Well Name: FEDERAL 8	Well Location: T22S / R32E / SEC 8 / SWNE /	County or Parish/State: LEA / NM
Well Number: 01	Type of Well: CONVENTIONAL GAS WELL	Allottee or Tribe Name:
Lease Number: NMNM90586	Unit or CA Name: FEDERAL 8 COM	Unit or CA Number: NMNM103144
US Well Number: 3002532709	Well Status: Gas Well Shut In	Operator: OXY USA INCORPORATED

Notice of Intent

Type of Submission: Notice of Intent	Type of Action: Plug and Abandonment
Date Sundry Submitted: 12/13/2022	Time Sundry Submitted: 07:34
Date proposed operation will begin: 01/13/2023

NOI TO PLUG AND ABANDON WELLBORE 12/13/22

Proposed Wellbore  
**FEDERAL 8 COM 001**  
30-025-32709-0000  
Lea  
Undes Red Tank Morrow

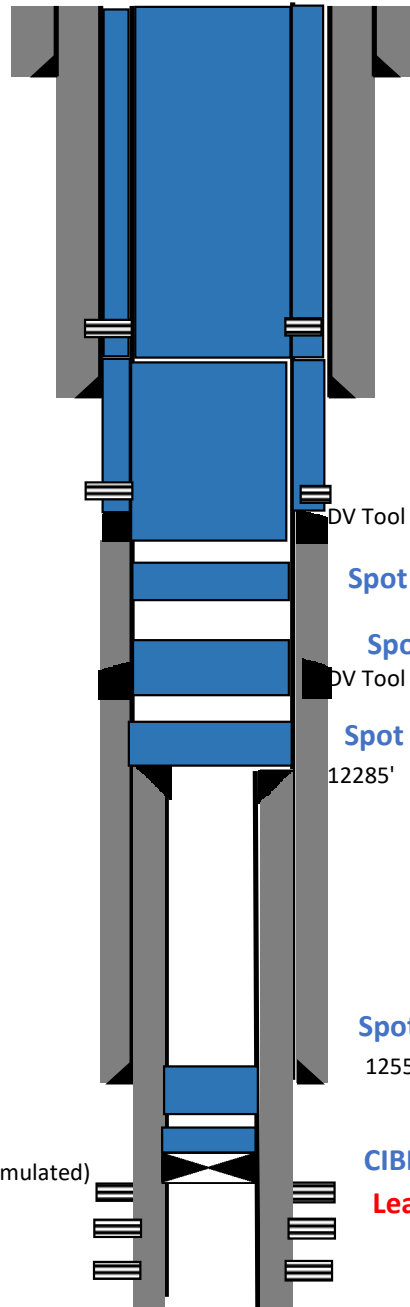
Perf @ 6921 ft above top DV tool, and  
squeeze cmt to 4500ft. 120 SX of cmt.

Spot ~~45 SX~~ of Cmt ~~8632-8885~~. WOC and TAG  
65sx 8825' 8545'

Sundry ID		2707014				
Plug Type	Top	Bottom	Length	Tag	Sacks	Notes
Surface Plug	0.00	4342.00	4342.00	Verify circulated to surface	785.00	Perf and sqz. Operator bringing BOS plug to surface. Secretary potash
Shoe Plug	759.82	868.00	108.18	Verify circulated to surface	785.00	Perf and sqz. Operator bringing BOS plug to surface. Secretary potash
Top of Salt @ 1015	954.85	1065.00	110.15	Verify circulated to surface	785.00	Perf and sqz. Operator bringing BOS plug to surface. Secretary potash
Base of Salt @ 4292	4199.08	4342.00	142.92	Verify circulated to surface	785.00	Perf and sqz. Operator bringing BOS plug to surface. Secretary potash
Shoe Plug	4464.40	4610.00	145.60	WOC and	120.00	Same as below plug
Delaware @ 4767	4669.33	4817.00	147.67	WOC and	120.00	Same as below plug
Perf and sqz plugs above 5500'						
DV tool plug	6118.69	6281.00	162.31	WOC and Tag	120.00	Perf and sqz
Bonesprings @ 8682	8545.00	8875.00	330.00	WOC and Tag	65.00	Same as below plug

DV tool plug	8545.00	8875.00	330.00	WOC and Tag	65.00	
Wolfcamp @ 11832	11663.00	12605.00	942.00		90.00	
Shoe Plug	11663.00	12605.00	942.00	WOC and Tag	90.00	
Morrow @ 14422	14227.78	14472.00	244.22	WOC and Tag	25.00	Covered by below plug
CIBP Plug	14378.00	14413.00	35.00	Verify depth	25.00	Leak test 500psi, 30mins
